FACILITY PLAN AMENDMENT
MONTROSE MUNICIPAL AUTHORITY
BRIDGEWATER TOWNSHIP MUNICIPAL AUTHORITY

ADDENDUM TO
FACILITY PLAN
MONTROSE MUNICIPAL AUTHORITY
BRIDGEWATER TOWNSHIP MUNICIPAL AUTHORITY

This addendum is prepared as an annex to the Facility Plan and essentially discusses questions or comments posed by the Pennsylvania Department of Environmental Resources (DER) and the U.S. Environmental Protection Agency (EPA) in letters of February 27, 1978 and November 28, 1978. A meeting was held on December 14, 1978 at EPA's Philadelphia office to discuss these and to determine a course of action. Those comments, and the responses, which are not included in the foregoing Amendment, are presented in this Addendum.

FIGURE A-4
LAKE MONTROSE AREA
U.S.S.C.S. SOIL MAP

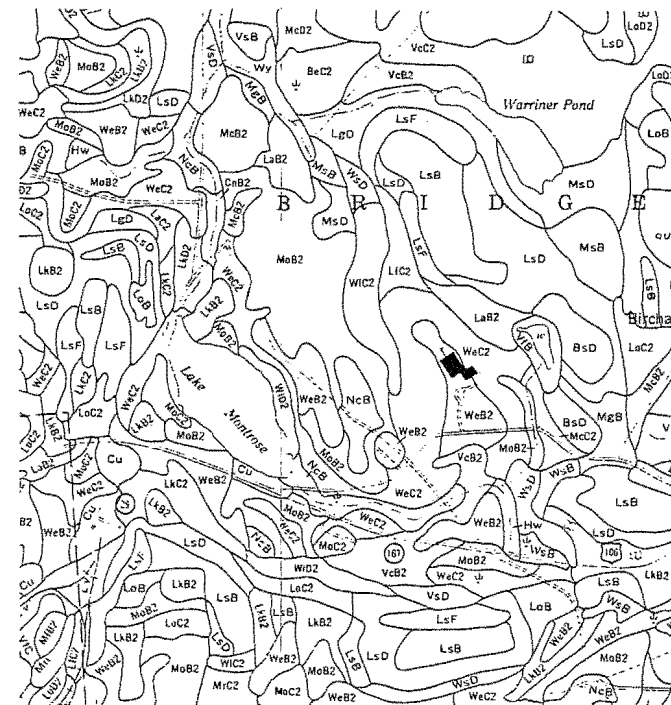
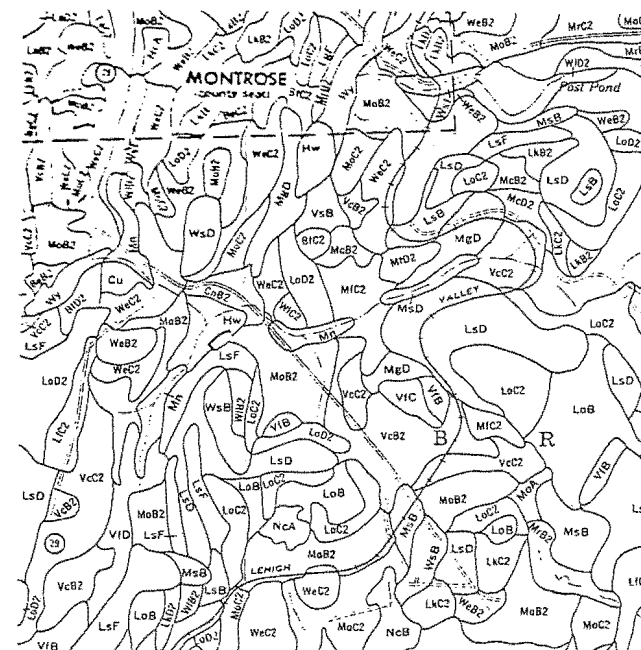
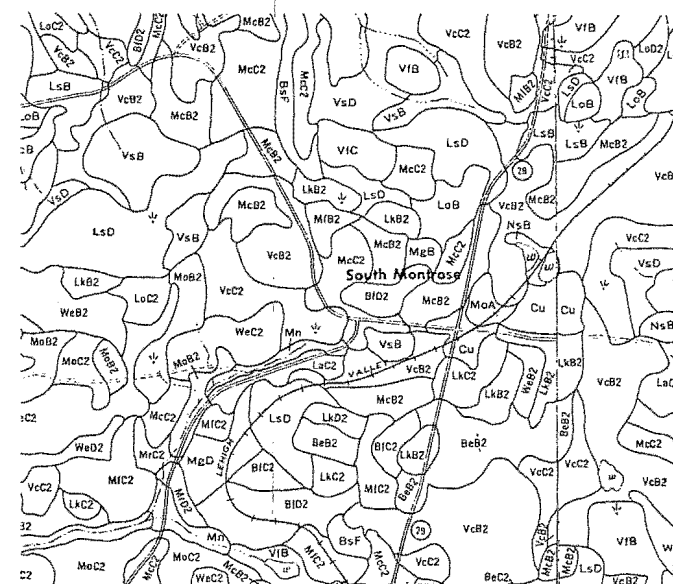
1) Comment

Soils Maps for the Study Area are included in the Facility Plan Amendment as part of the PRM 78-9 work.

FIGURE 8.3
PLOT PLAN OF PROPOSED
SEWAGE COLLECTION FACILITIES

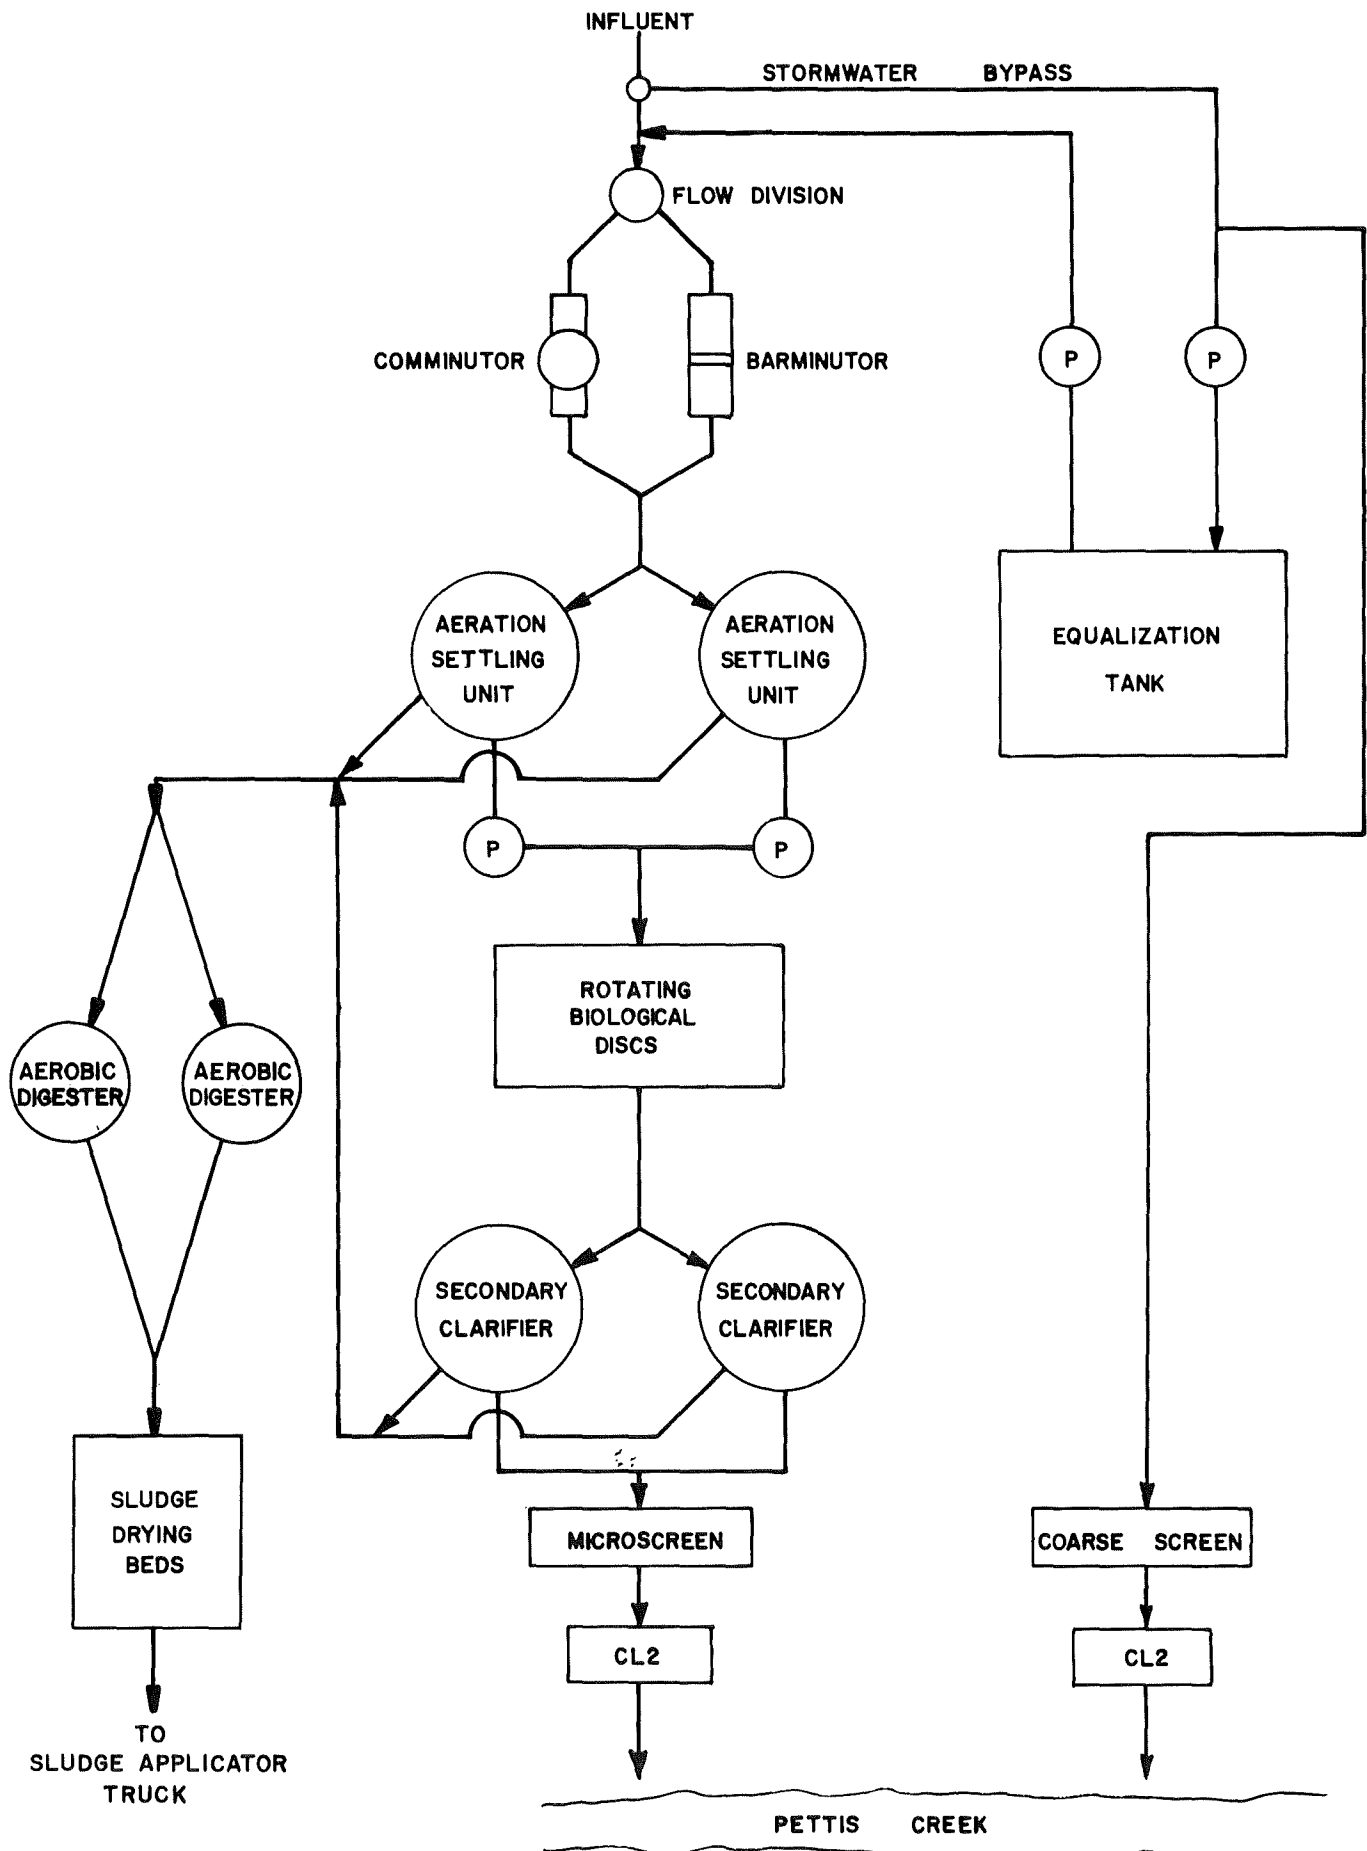
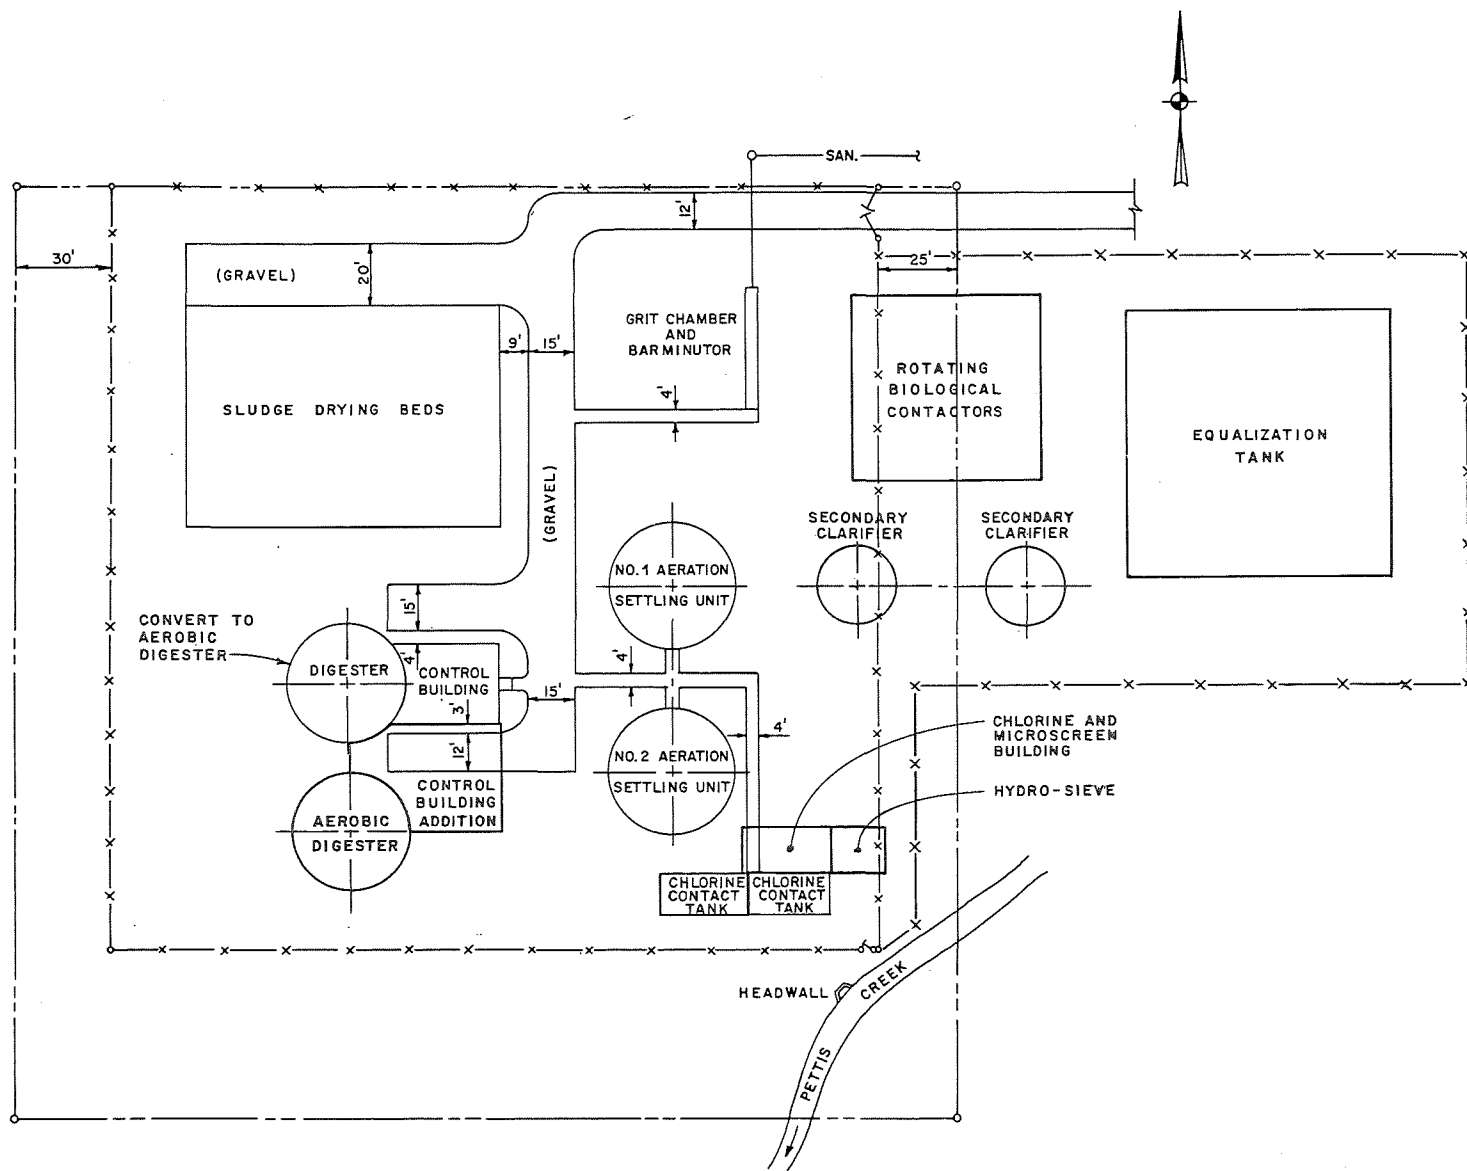
Page 6-13 and Figure 8.3. PRM 78-9 requirements must be addressed for entire study area.

This is discussed in the Facility Plan Amendment.
